International Linear Collider  
at Stanford Linear Accelerator Center

# MDI Questions to Concept Groups

## IR/Detector Design, Geometry, Magnets

Tom Markiewicz/SLAC  
Snowmass 2005  
17 August 2005

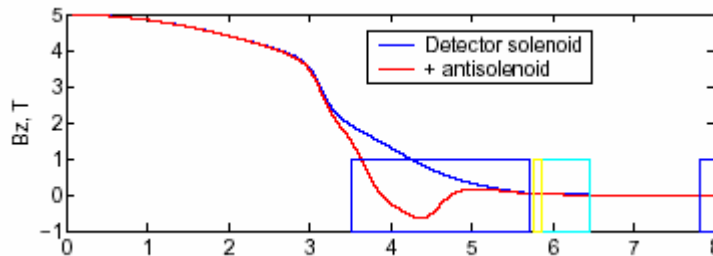
A. Seryi & Y. Nosochkov analyzed this (LCC-Note 142) and showed for the then Si D detector and (now defunct) LD concept that even though traditional use of skew quads could reduce the effect **LOCAL COMPENSATION** of the fringe field (with a little skew tuning) was the best way to ensure excellent correction over wide range of beam energies

Si D or LD  
 $\sigma_y / \sigma_y(0) < 1.01$

# Preliminary Design of Anti-solenoid for Si D (B. Parker)

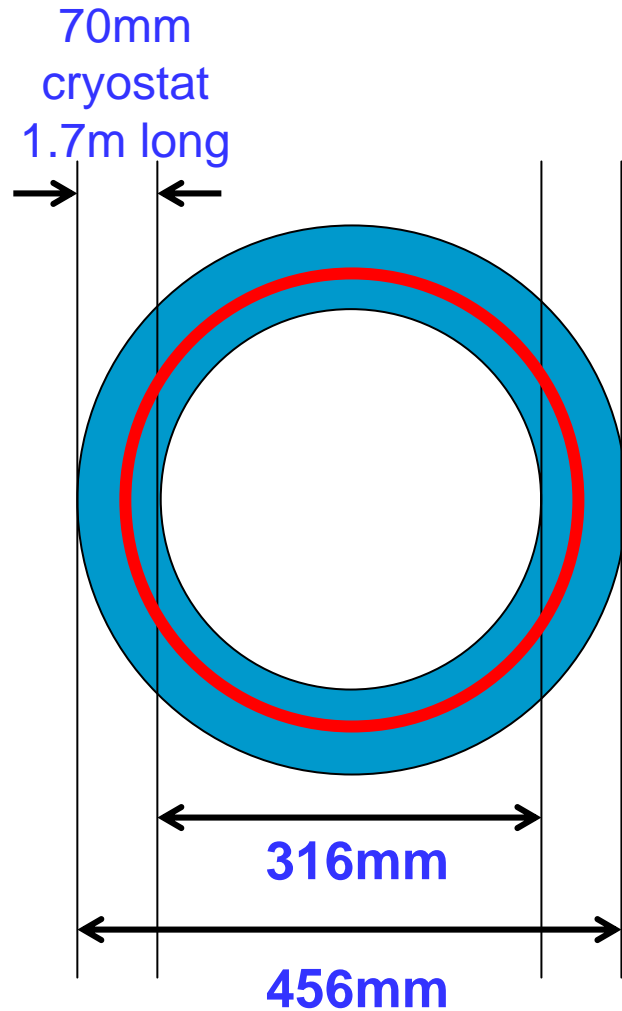
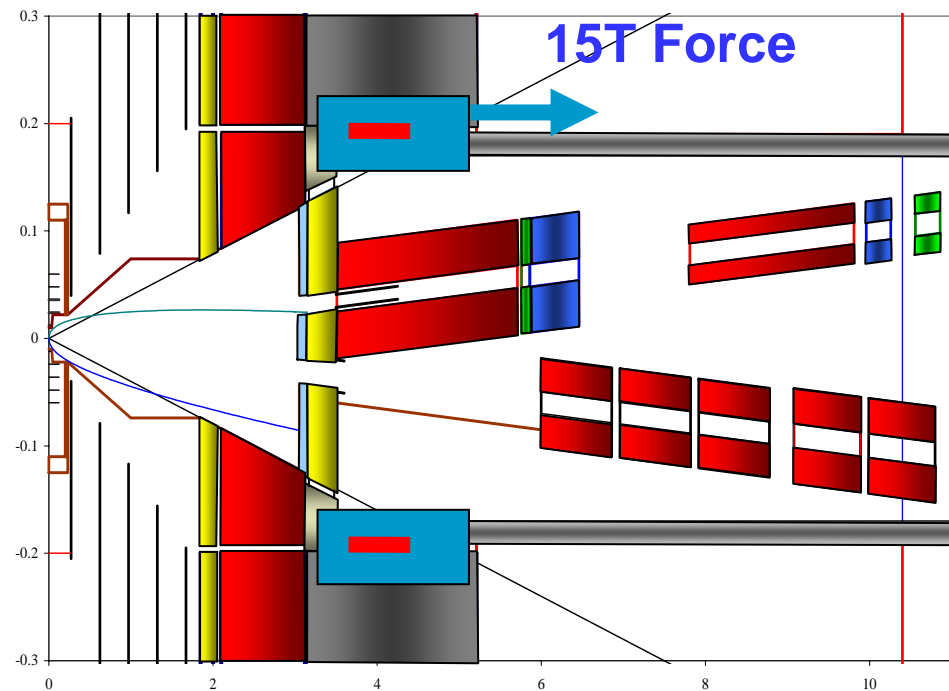
This work needs to be repeated for each detector  
concept and for each crossing angle FD  
Replies from concept groups indicated that work to  
incorporate these coils needs to be done

## Q12: Local Solenoid Compensation for 20mrad crossing angle

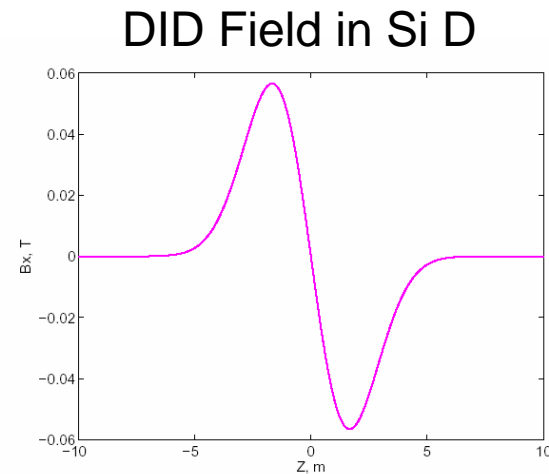
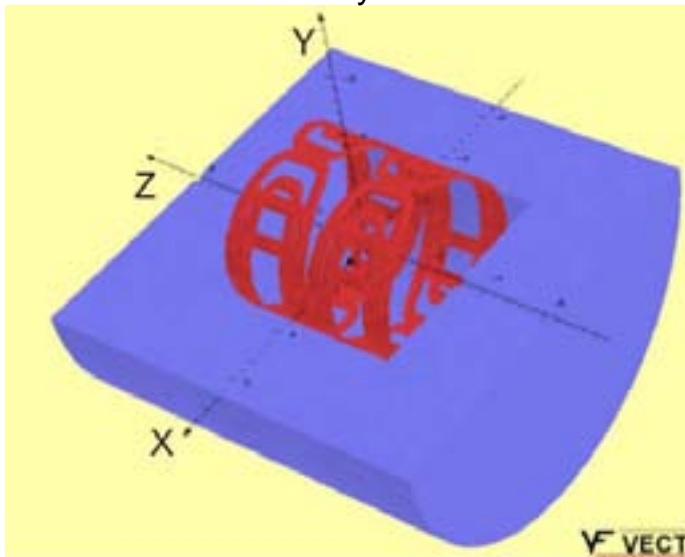
Q12 asks each detector concept if they can deal with it:

- GLD: Work in progress by R. Settles
- Si D: Needs study but gut feeling is that it is OK
- LDC: Tracking issues need study but point to increased TPC backgrounds in current masking due to redirection of  $e^+e^-$  pair background

A. Seryi & B. Parker showed (LCC-Note 143) that if the solenoid transverse field component is **locally compensated** with a “Detector Integrated Dipole” (DID) coil wound with the main solenoid then  $\sigma_y(\text{Solenoid}) / \sigma_y(0) \sim 1.03$

## Q17 & 18: Si D and LDC Assembly & Commissioning Model

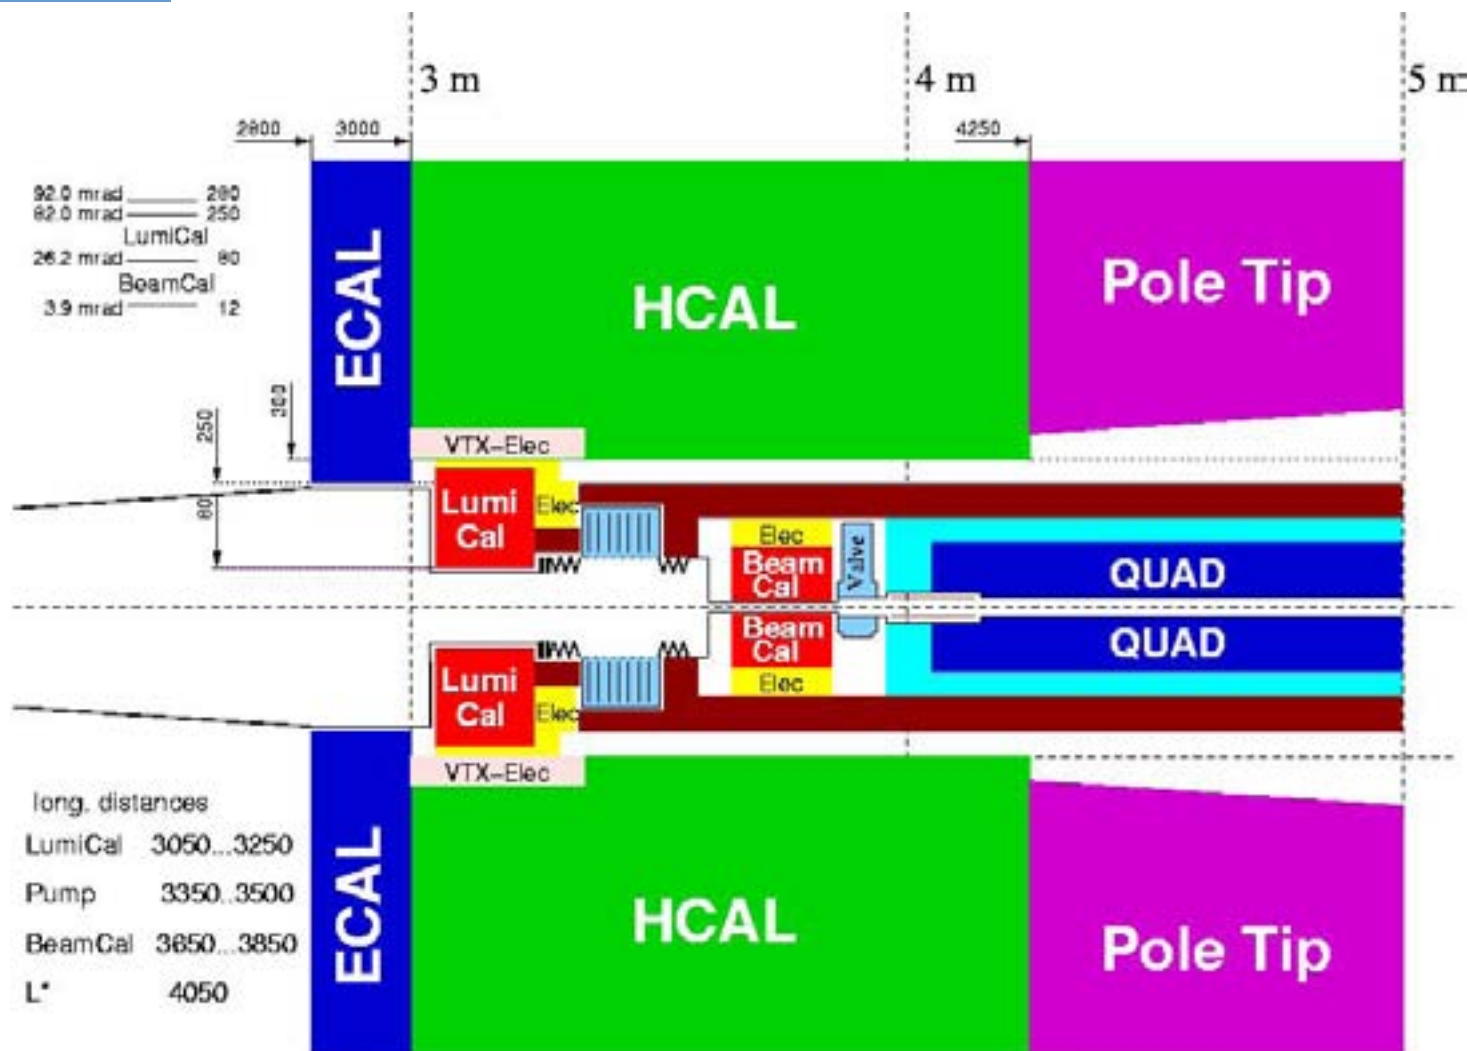
- **Si D:**
  - No current answer
  - Personal guess is that it will be similar to 1999 SD/LD study
- **LDC**
  - Assembly as per TESLA TDR with 2004 addendum for modified forward calorimetry
  - Hall size to be discussed at Snowmass

## Q2: Si Detector components with $r < 50\text{cm}$

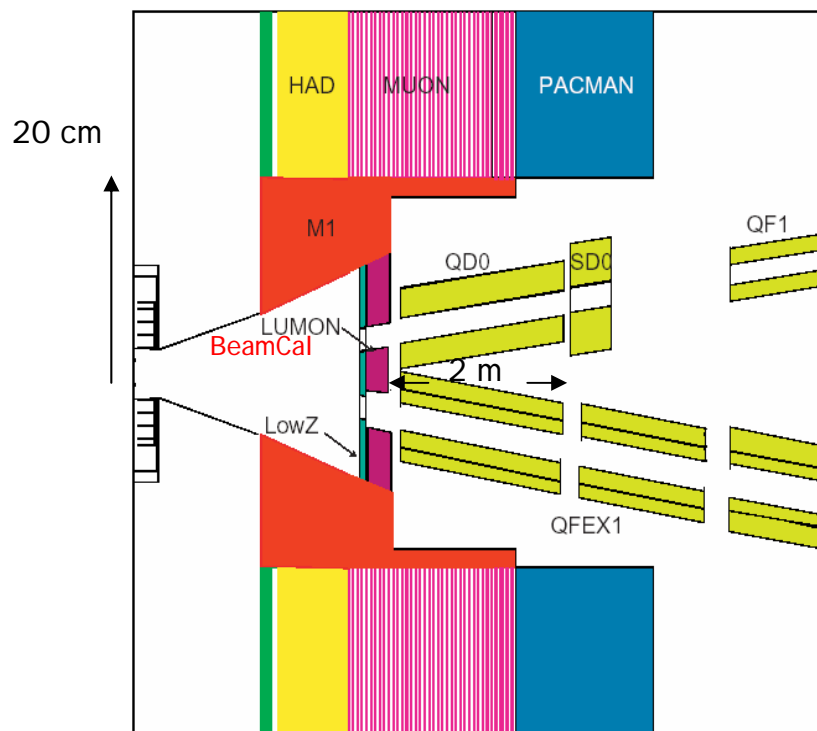
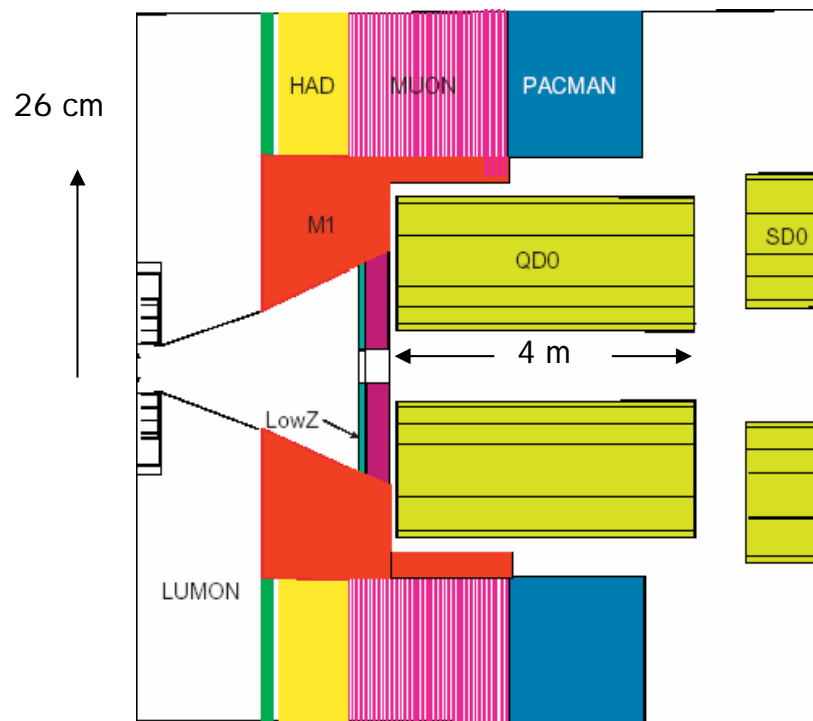
Current understanding of 2mrad and 20mrad optical elements incorporated  
Solenoid compensator and rudimentary engineering lacking

## Q10: Minimum angle for electron tagging

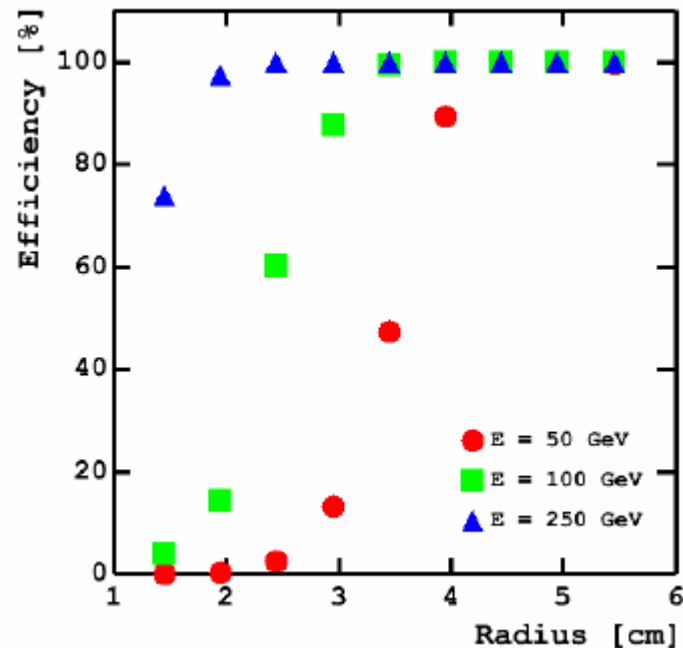
- **GLD:**
  - Minimum angular acceptance of BCAL is 5rad
  - Need full simulation to study the efficiency of tagging electrons in high pair background as a function of crossing angle
    - Under study
- **LDC**
  - Under study
- **Si D**
  - Needs a detailed simulation before can answer
